UNITED STATES PATENT AND TRADEMARK OFFICE

APPLICATION NO.	FILING DATE	FIRST NAMED INVENTOR	ATTORNEY DOCKET NO.	CONFIRMATION NO.
10/617,791	07/14/2003	Shinjiro Hara	BD-0302T	4079
7590	06/18/2007			
Takeuchi & Kubotera, LLP 200 Daingerfield Road Suite 202 Alexandria, VA 22314				EXAMINER SEVERSON, JEREMY R
ART UNIT 3653		PAPER NUMBER		
MAIL DATE 06/18/2007		DELIVERY MODE PAPER

DETAILED ACTION

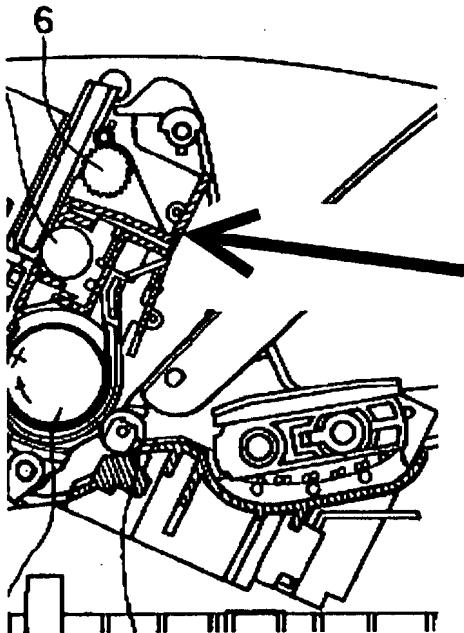
Re claims 3 and 6, Nishiberi discloses everything claimed, including a restricting member arranged at said medium support or rear guide and restricting said record medium put in said depository such that said record medium is not spaced from said medium support or rear guide more than a predetermined distance and is transported along said medium support or rear guide when said record medium is fed into said image recording apparatus. Arrow in fig. below points to restricting member.
